Subject: AP1000 COL Response to Request for Additional Information (TR 36)

Response to Request for Additional Information on Technical Report No. 36

RAI Response Number: RAI-TR36-012

Figure 2-1  
Turbine Trip  
(Peak Pressure Case)

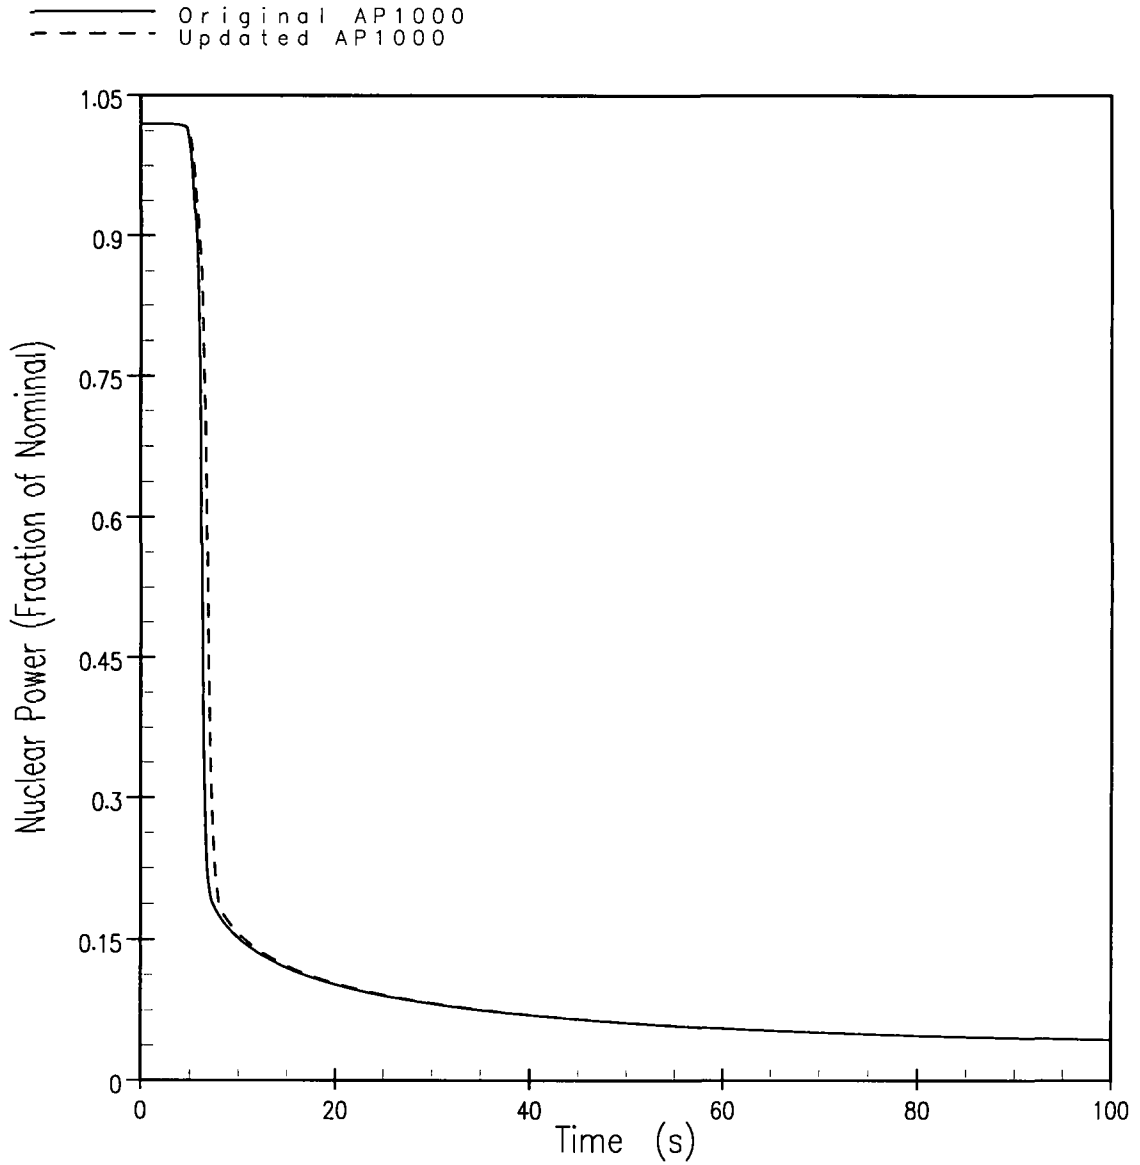
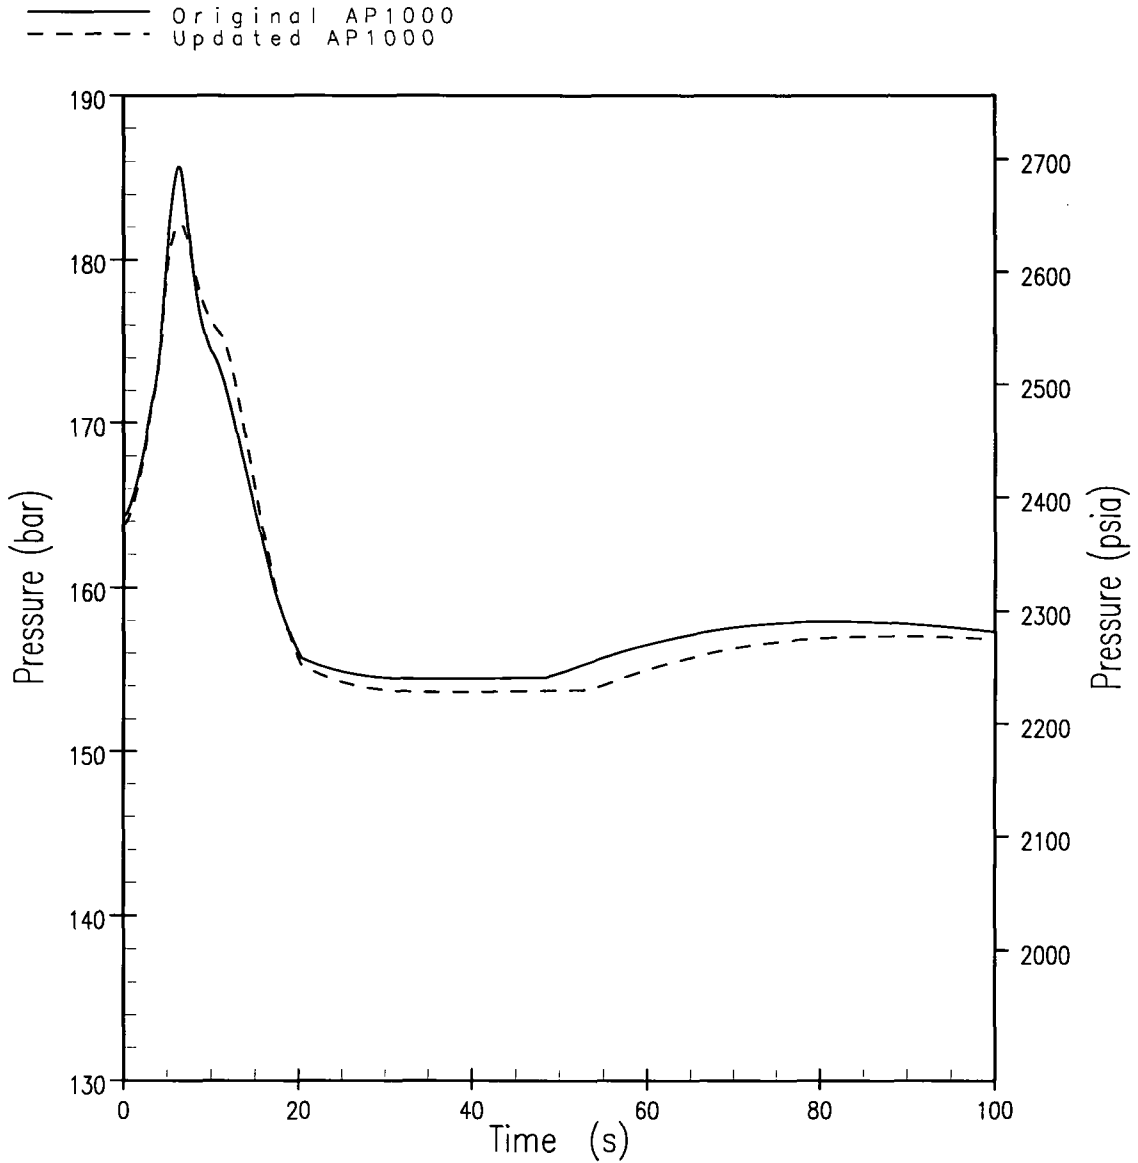
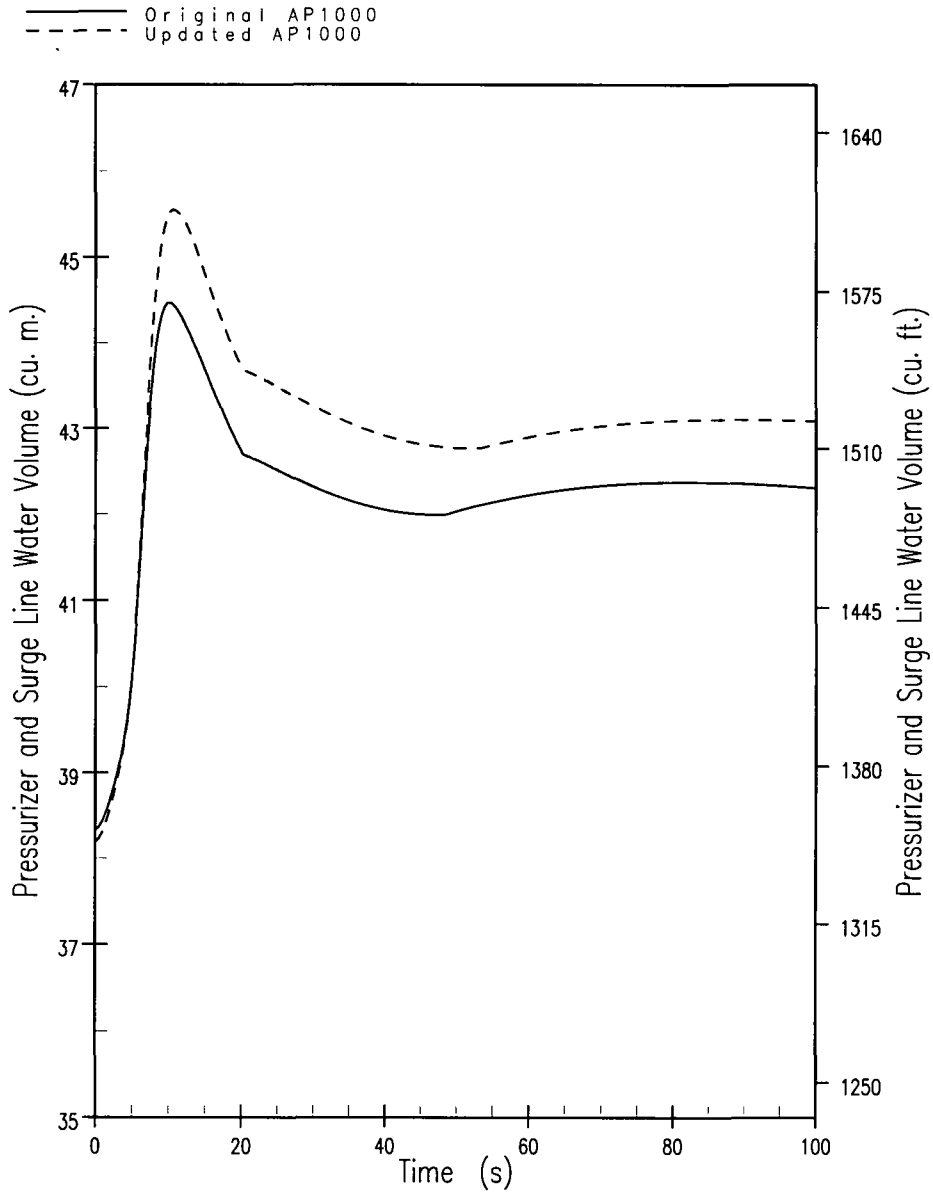
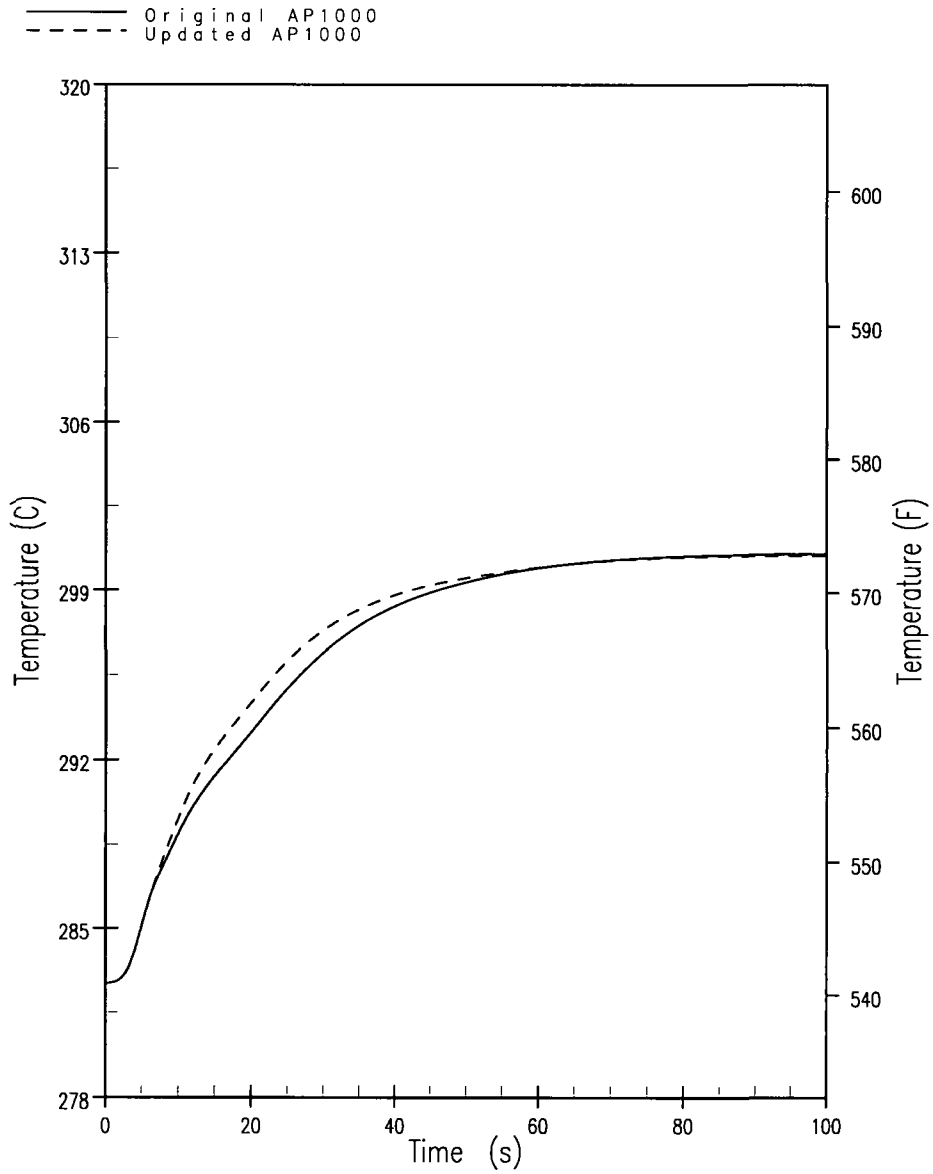
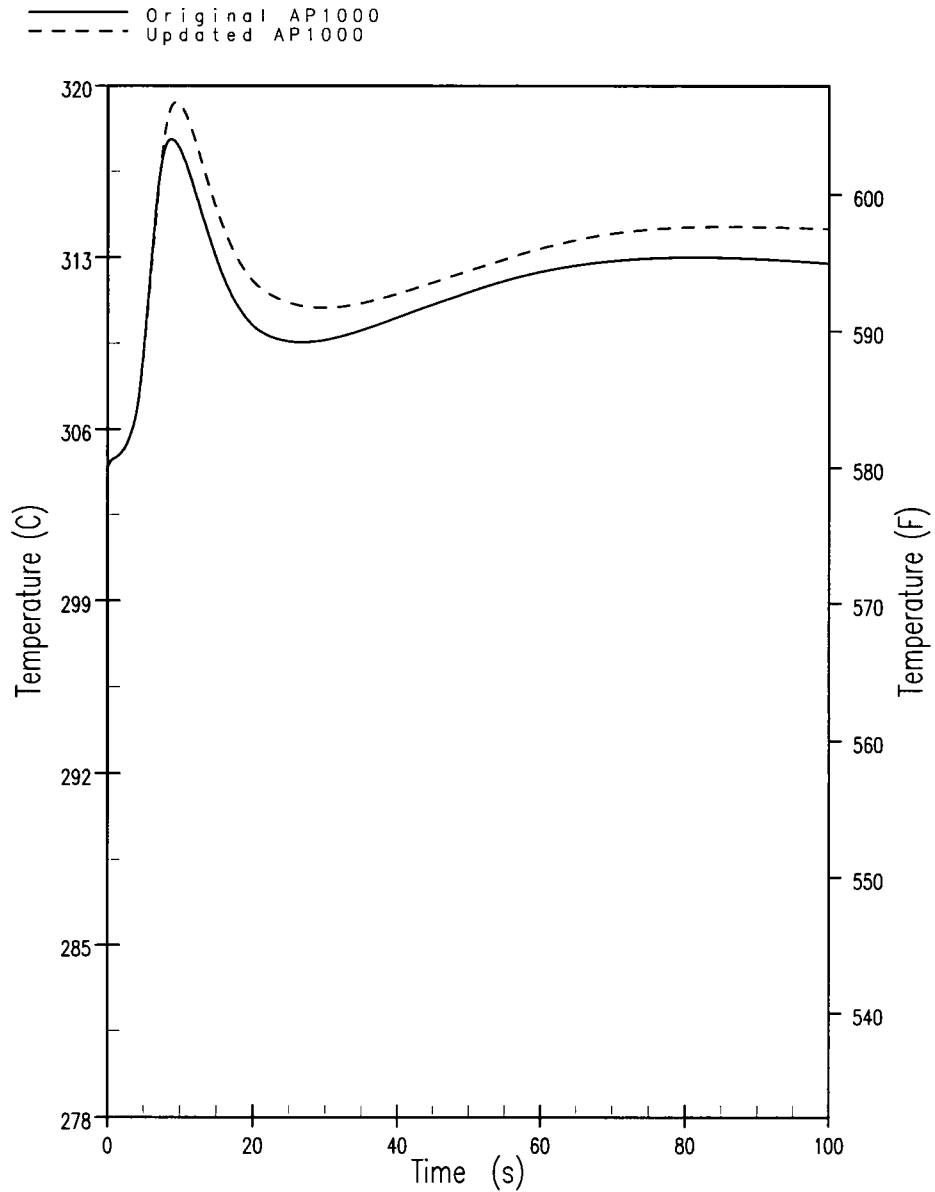
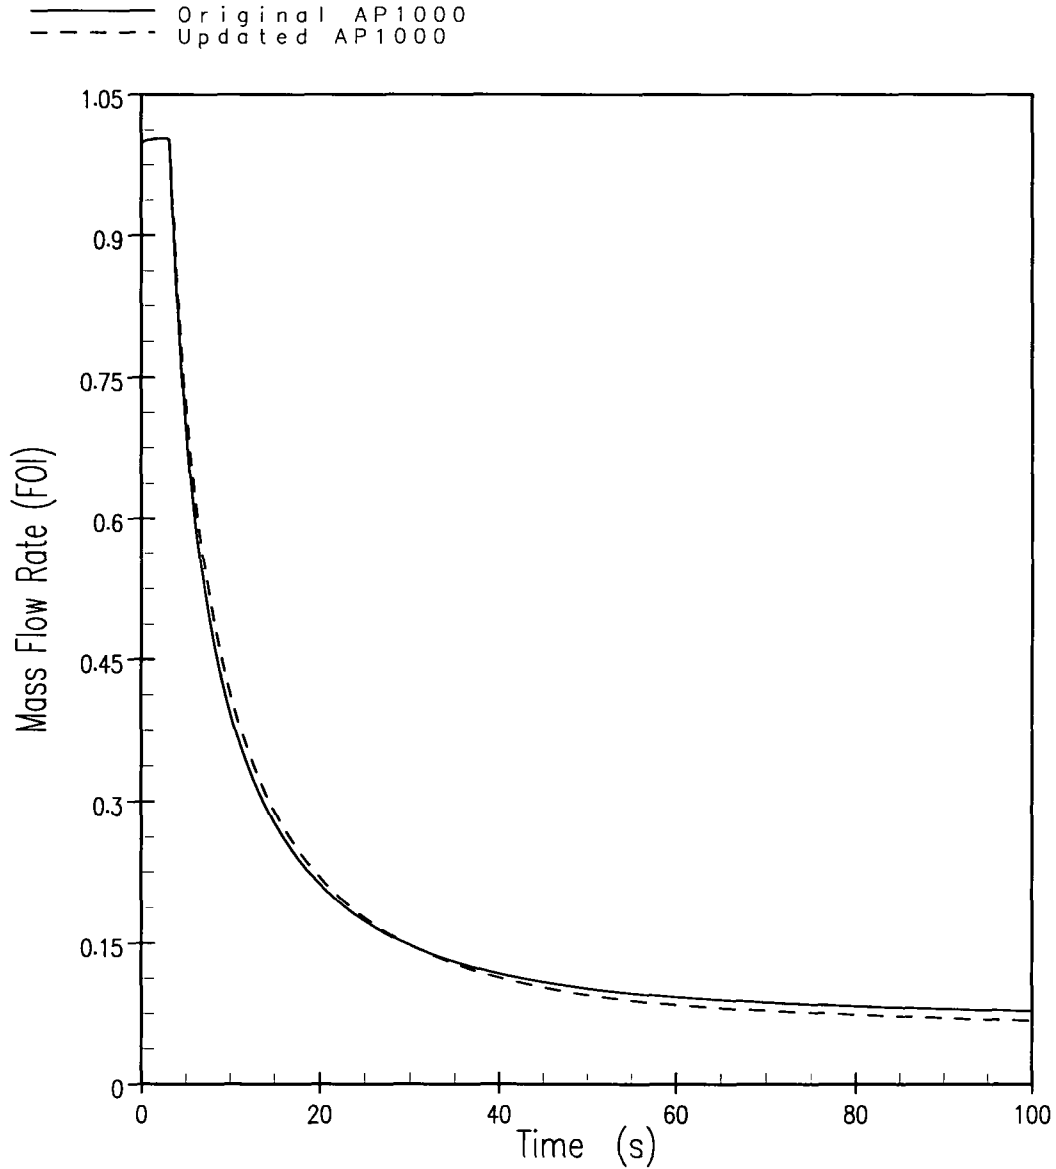
The pressurizer changes affect many parameters such as the cross-sectional area of the pressurizer, pressurizer vessel height, initial pressurizer water level, pressurizer setpoints, ADS stages 1, 2, and 3 elevation and pressurizer heater length. We are concerned about the combined effects of the values changed for the above parameters on the thermal hydraulic response during transient and accident conditions. We determined that the qualitative statement in the RAI response is not sufficient to resolve the RAI issue. We request Westinghouse perform the quantitative analyses for the limiting event for each of the following Standard Review Plan chapter 15 event categories:

The most limiting case with respect to maximizing reactor coolant pressure occurs without the pressurizer pressure control system available, with minimum reactivity feedback and without offsite power available. Results for this case are shown in Figures 2-1 through 2-6. A sequence of events for this case is provided in Table 2-1 and is identified as Case C.2. The maximum reactor coolant pressure for the updated AP1000 configuration is 2642.36 psia [182.2 bar] as compared to 2693.65 psia [185.7 bar] in the original AP1000 plant configuration. The over pressurization results are less severe for the updated AP1000 plant.
